Product Change Notification

Change Notification #: 111822 - 00
Change Title: Intel® Server Chassis H2216XXJR and H2312XXJR
Intel® Server System H2216JFFJR, H2216JFJR, H2216JFQJR, H2216LPJR, H2216WPFJR, H2216WPJR, H2216WPQJR, H2312JFFJR, H2312JFJR, H2312JFQJR, H2312LPJR, H2312WPFJR, H2312WPJR and H2312WPQJR
PCN 111822-00, Product Design
Chassis Mechanical Changes
Date of Publication: October 31, 2012

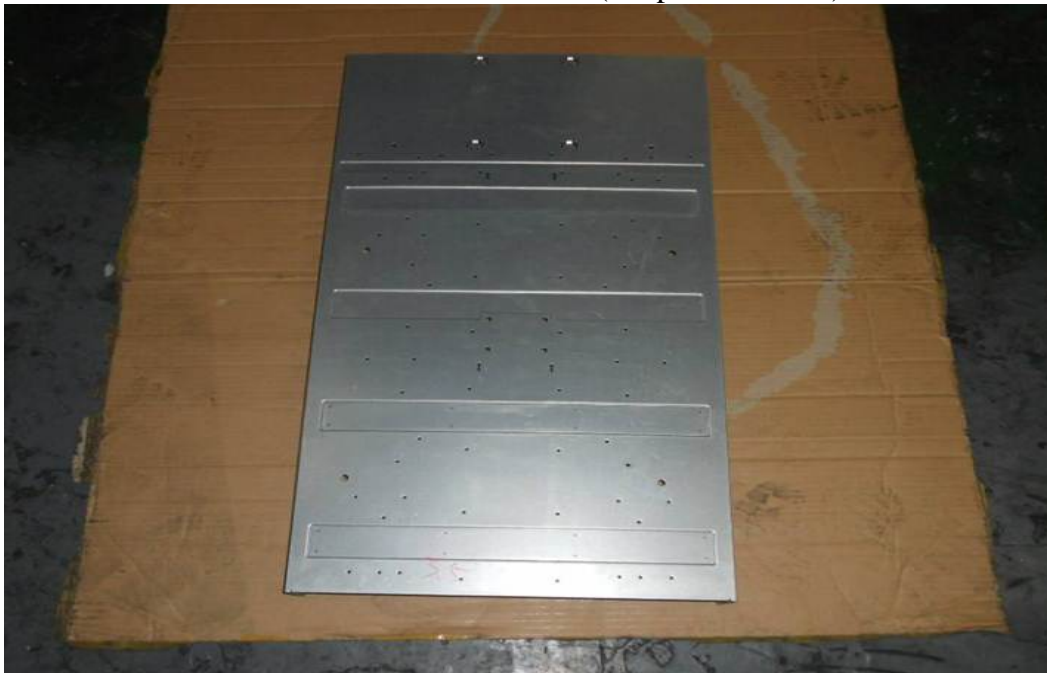
The Chassis base architecture has been strengthened to resolve an issue where the middle of the chassis may sag when the system is installed in a rack.

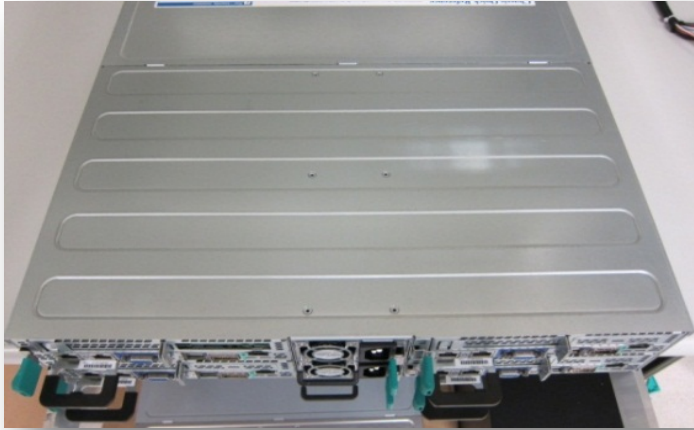
1. Added 4 emboss areas on the chassis base (see picture below).
